Product Change Notification / KSRA-16XDWZ131

CCB 4198.002 Final Notice: Qualification of ASSH as a new assembly site for selected 25AA640xx and 25LC640xx device families of 36K wafer technology available in 8L TSSOP package.

CCB 4198.002
Pre and Post Change Summary
PCN #: KSRA-16XDWZ131

PCN#: KSRA-16XDWZ131

Lead frame comparison

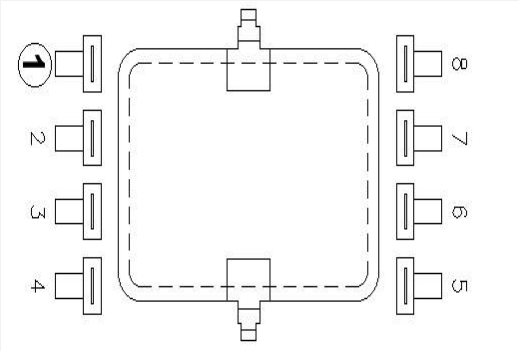
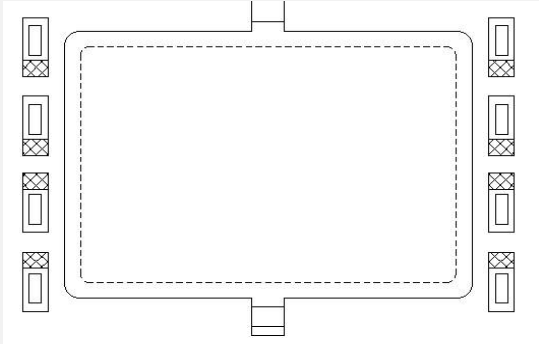
| | Pre Change | | | | Post Change | | | | |
|----------------------------------|---|--|---------------------------------------|-------------------------------------|--|--|---------------------------------------|-------------------------------------|---|
| Lead frame lead-lock | See Pre and Post Change attachment for lead frame comparison. | | | | | | | | |

| ANAP | | UNIS | | NSEB | |
|----------------------|----|----------------------|----|----------------------|-----|
| Lead frame lead-lock | No | Lead frame lead-lock | No | Lead frame lead-lock | Yes |

| MMT | ASSH | | | | |
|---|----------------------|----|--|----------------------|-----|
|  <table border="1" data-bbox="180 1247 664 1297"> <tr> <td>Lead frame lead-lock</td> <td>No</td> </tr> </table> | Lead frame lead-lock | No |  <table border="1" data-bbox="948 1247 1432 1297"> <tr> <td>Lead frame lead-lock</td> <td>Yes</td> </tr> </table> | Lead frame lead-lock | Yes |

Assembled at ASSH using palladium coated copper (PdCu) bond wire, EN-4900GC die attach material, G700LY molding compound material, with PPF lead plating finish and using lead frame with lead lock
